PIC16C73B Rev. A Silicon Errata Sheet

The PIC16C73B (Rev. A) parts you have received conform functionally to the Device Data Sheet (DS30605A), except for the anomalies described below.

FIGURE 1: $\overline{\text{MCLR}}$ EXTERNAL CIRCUIT

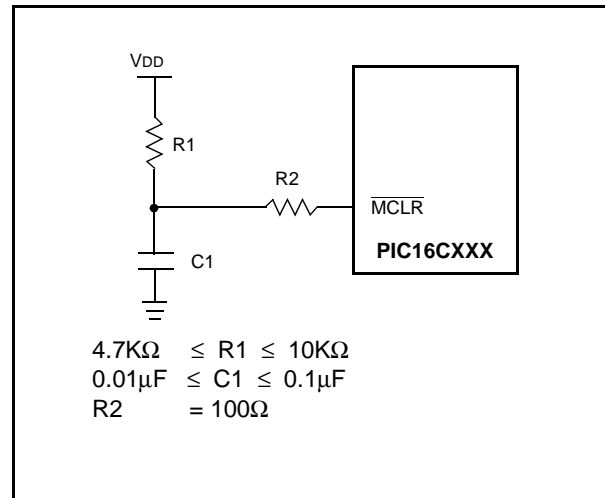
The minimum specification for the $\overline{\text{MCLR}}$ must be met in order to RESET the PIC16CXXX. If a $\overline{\text{MCLR}}$ pulse occurs that is less than the minimum specification (parameter #30), improper device operation can occur.

If the minimum specification cannot be met, then an external circuit must be used to insure that any pulse width less than the specification will be filtered before it reaches the $\overline{\text{MCLR}}$ pin.

A possible circuit is shown in Figure 1. Proper design validation needs to be done to ensure desired operation over the applications operating conditions

Figure 2: Wake-up from Sleep

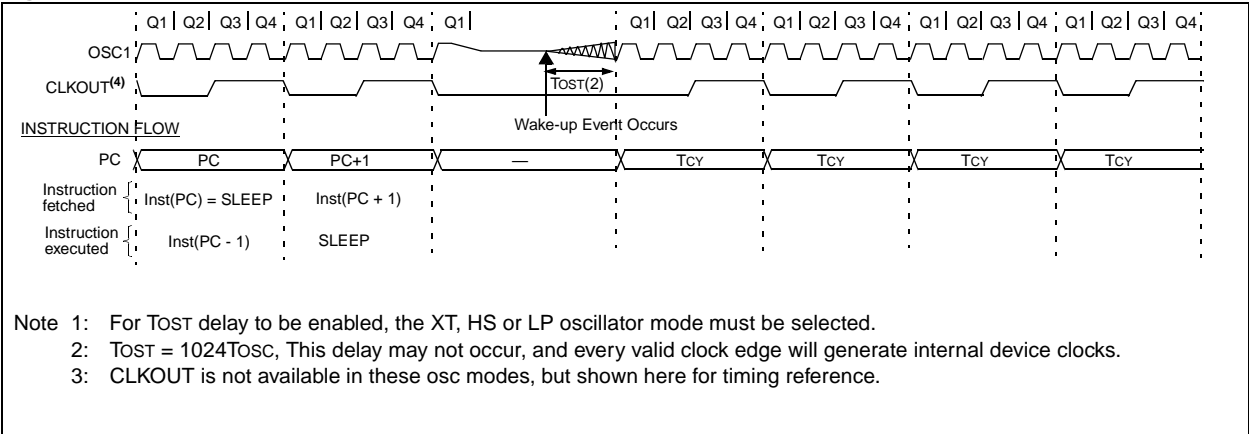
The Oscillator Start-up Timer (TOST) delay may not occur when the device wakes-up from sleep.

Figure 2 shows the start-up of the crystal after the event that causes the device to wake up from sleep mode (as specified in device data sheet). The start-up time (TOST) may not occur.

After the SLEEP instruction, do a software delay of 256 Tcy (same as 1024 TOSC). At the Reset and Interrupt vector addresses, test to see if the device woke from sleep (the $\overline{\text{TO}}$ and $\overline{\text{PD}}$ bits), and if the device did wake from sleep, ensure that the total cycle delay is 256 Tcy.

Figure 3: PIC16CXXX Voltage-Frequency Graph

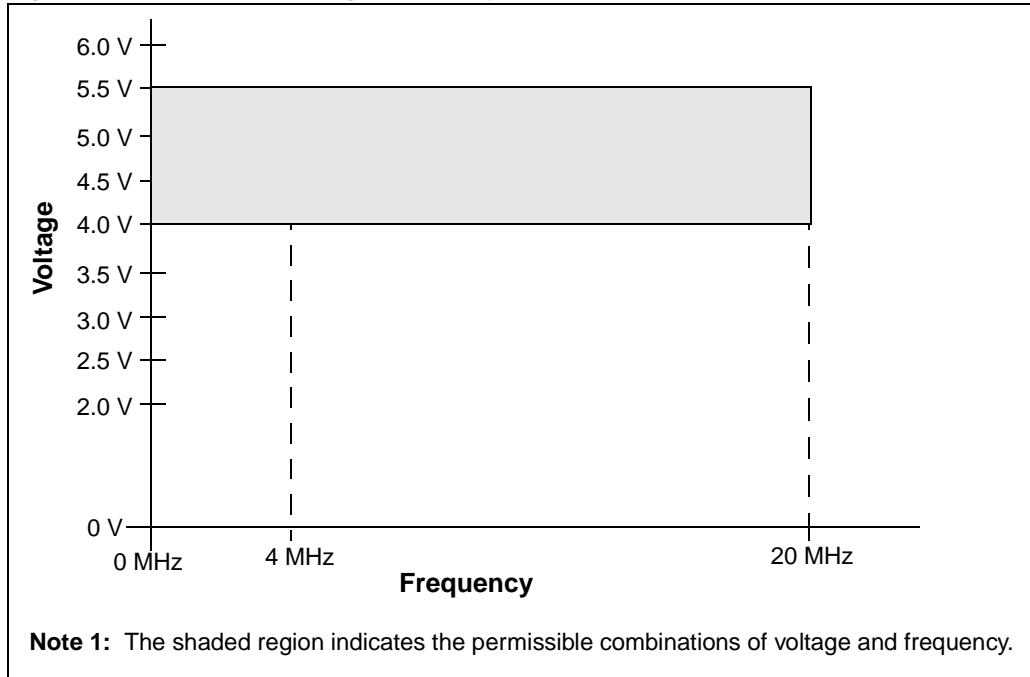
- Figure 3 and Figure 4 are additions to the data sheet to show the area of operation. These figures replace the Cross Reference of Device Specs for Oscillator Modes Table in the Electrical Specification section.

Figure 3 shows the voltage vs. frequency operation for the PIC16CXXX devices. Devices marked with a "-04" operate up to 4 MHz, while devices marked with a "-20" operate up to 20 MHz. The entire shaded region is the valid operating region.

Figure 4: PIC16LCXXX Voltage-Frequency Graph

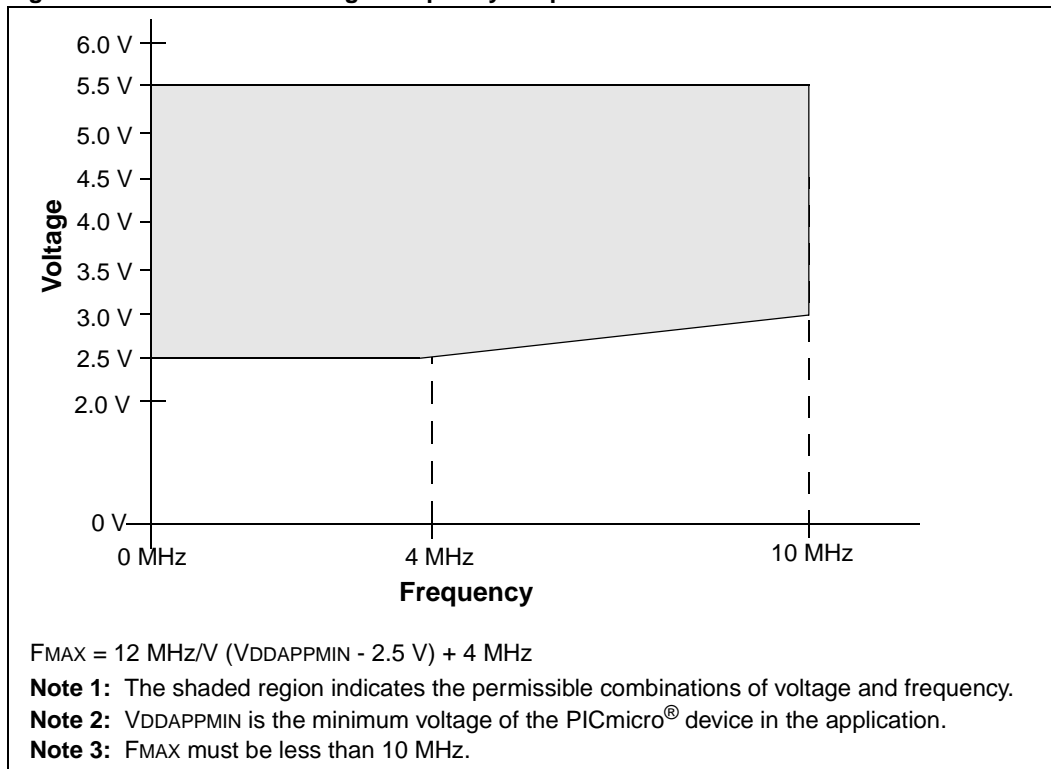
Figure 4 shows the voltage vs. frequency operation for the PIC16LCXXX devices. The devices marked with a "-04" operate up to 4 MHz at the minimum supplied voltage. The devices also operate at a higher frequency (10 MHz) and at a higher voltage (3V). The entire shaded region is the valid operating region.
